ADDENDUM 1 (PENDING DSA APPROVAL)

PROJECT: **Santa Ana College**
 Science Center

DATE: 8/23/2017

DSA File No.: 30-C2
DSA Applications No.: 04-115788
HGA Commission No.: 3584-001-00

A432

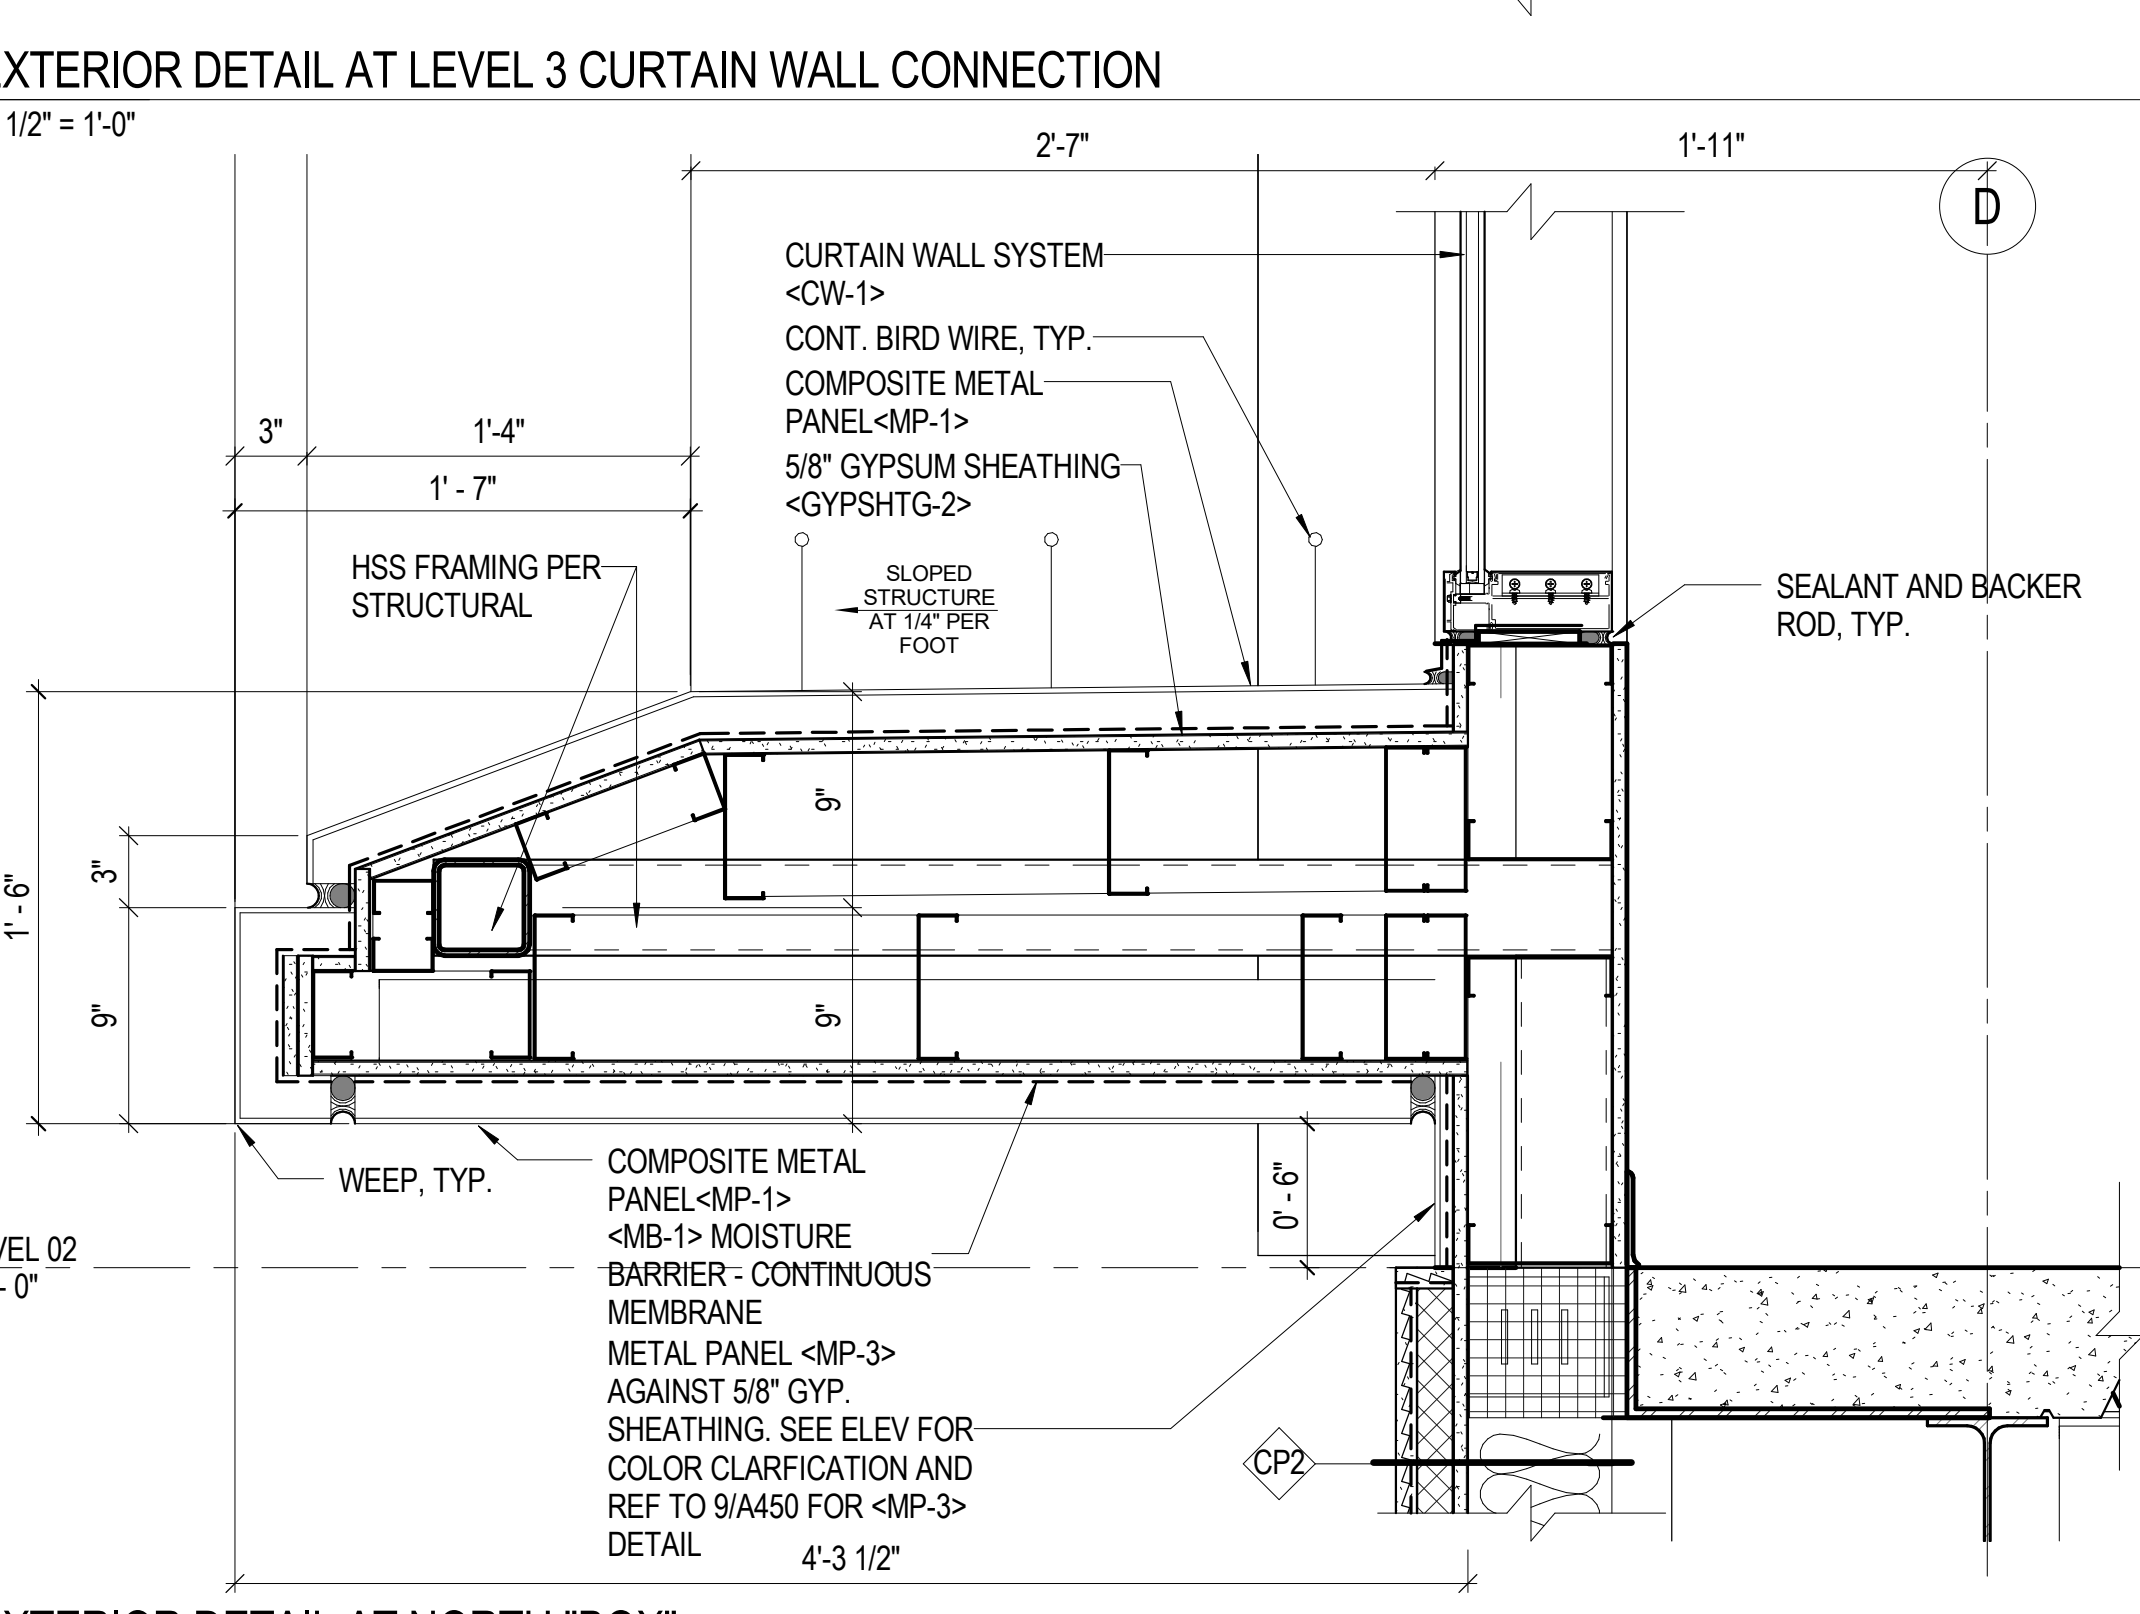
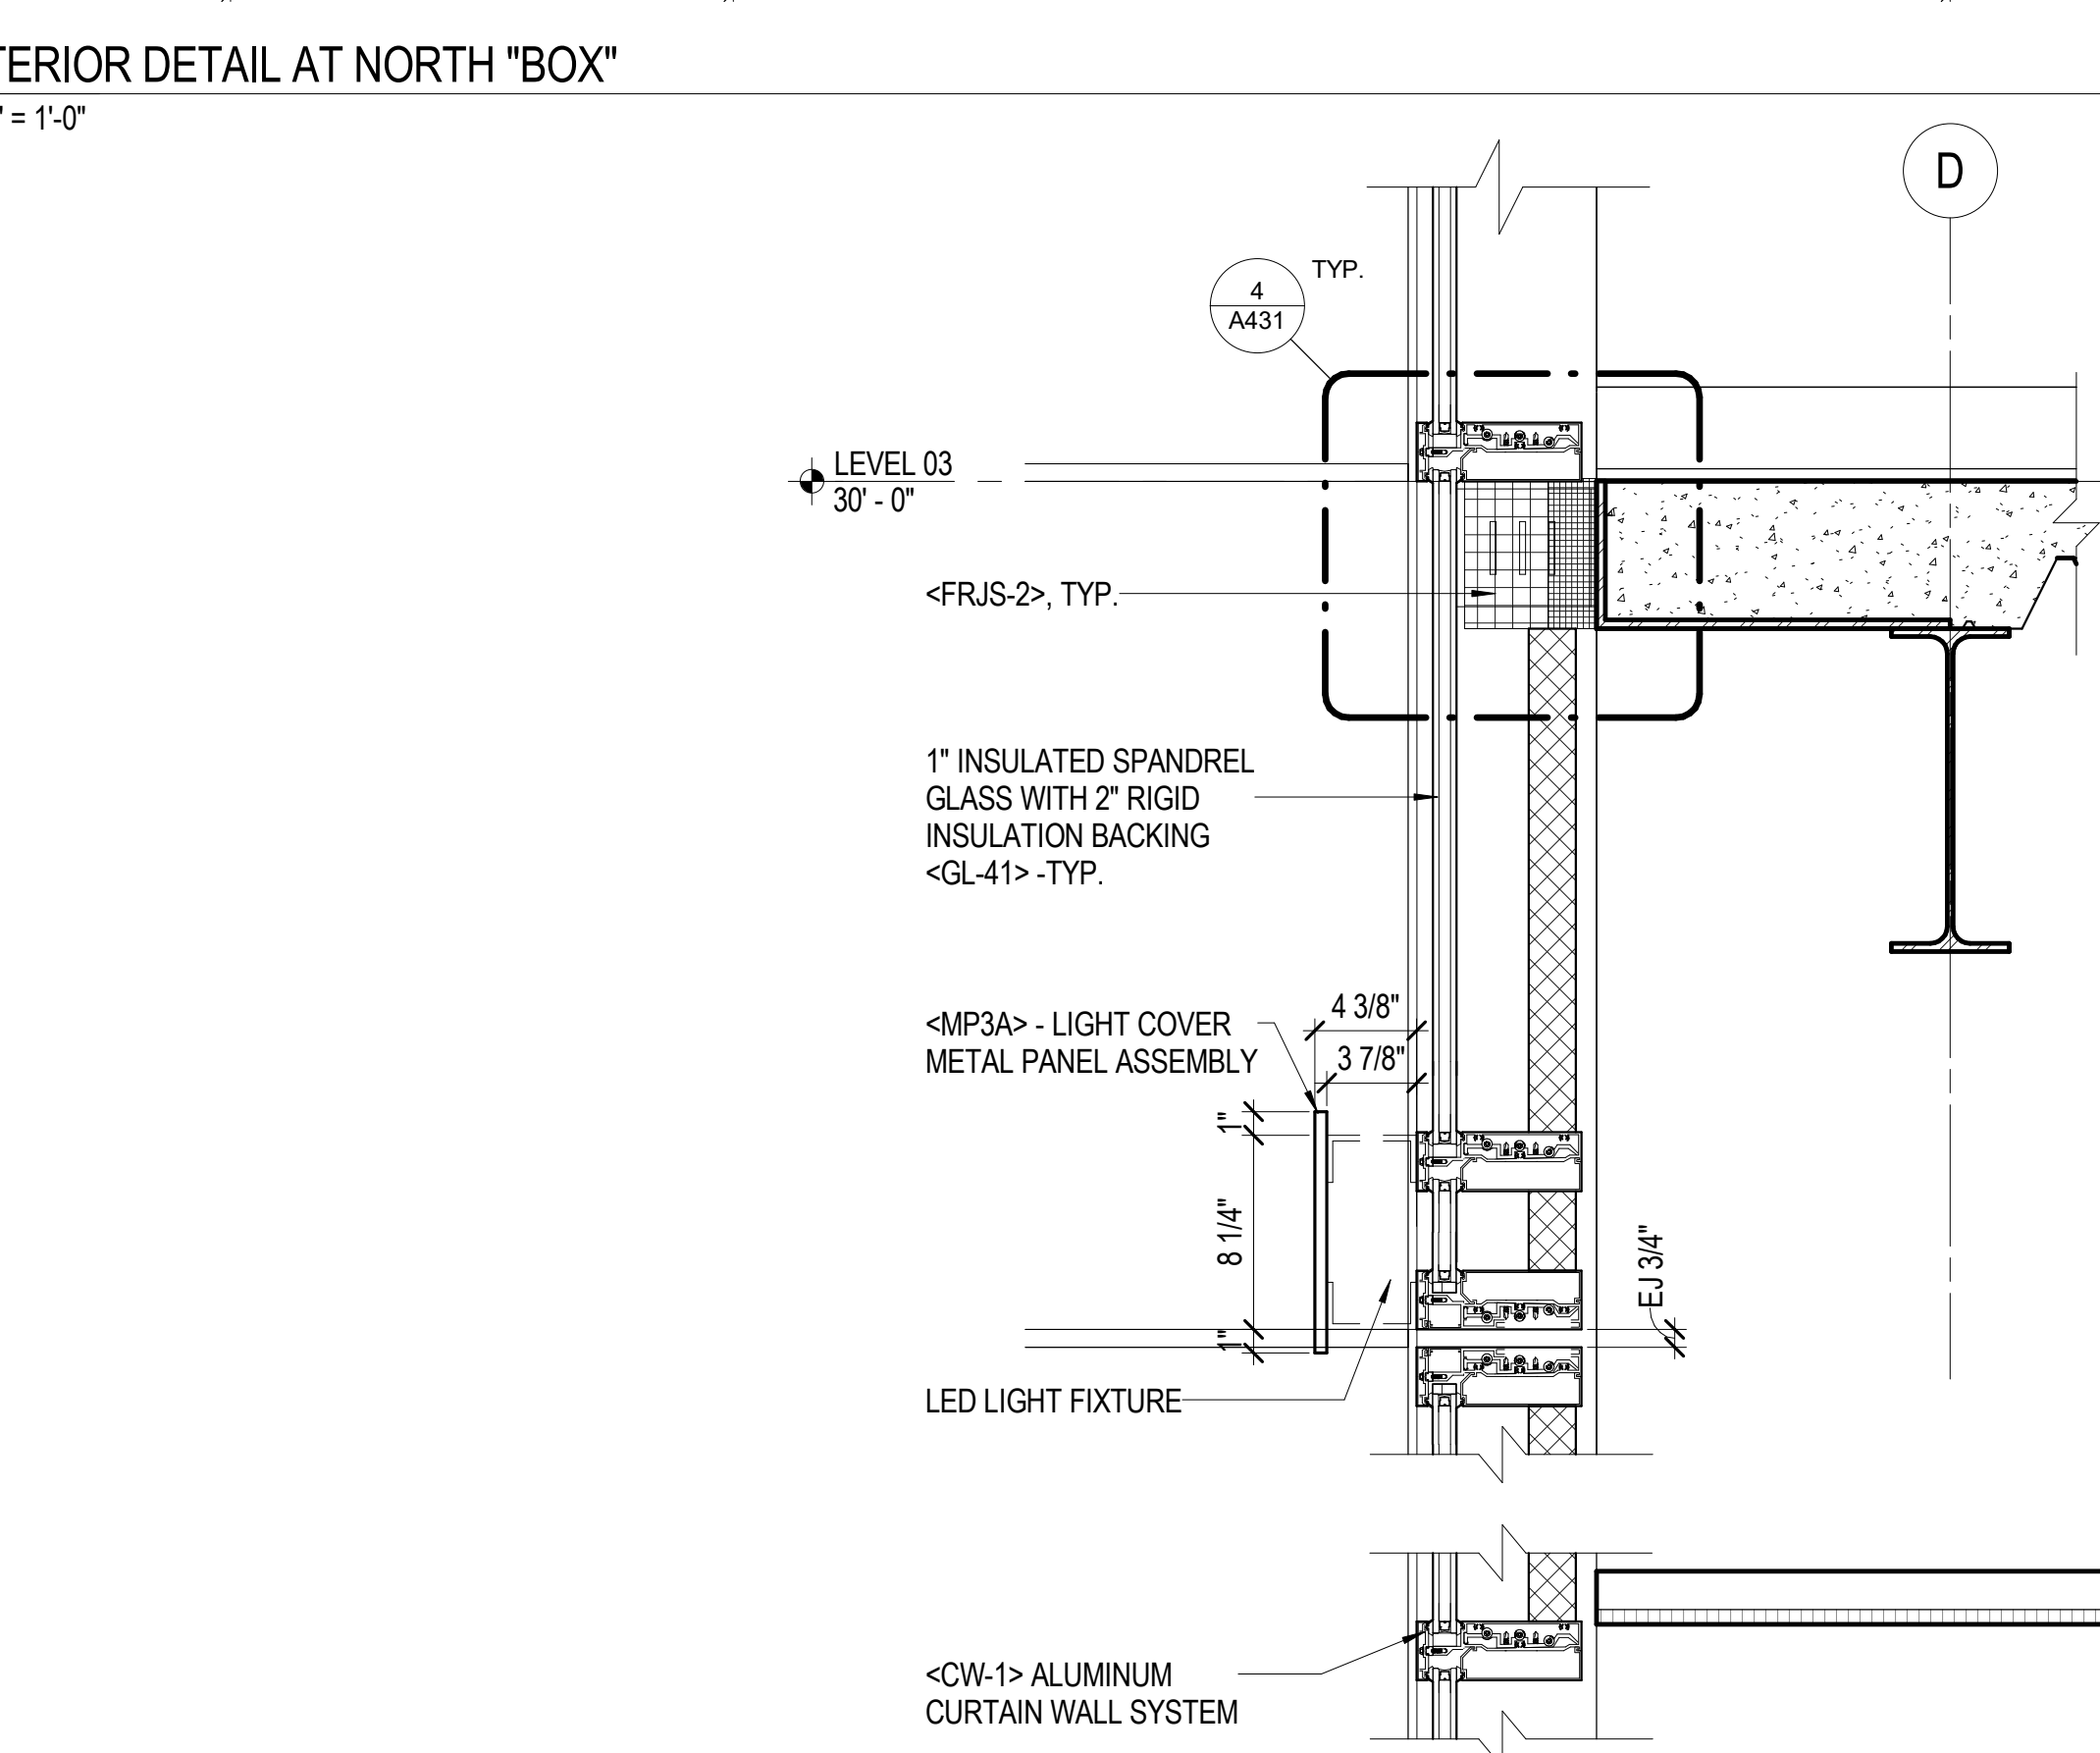
- North canopy reduced by 5'-0" at Details 5, 8, and 9.
- Gutter removed from roof at north canopy at Details 5.
- Framing at canopy revised to match structural drawings at Details 5, 6C, 7, 8, and 9.
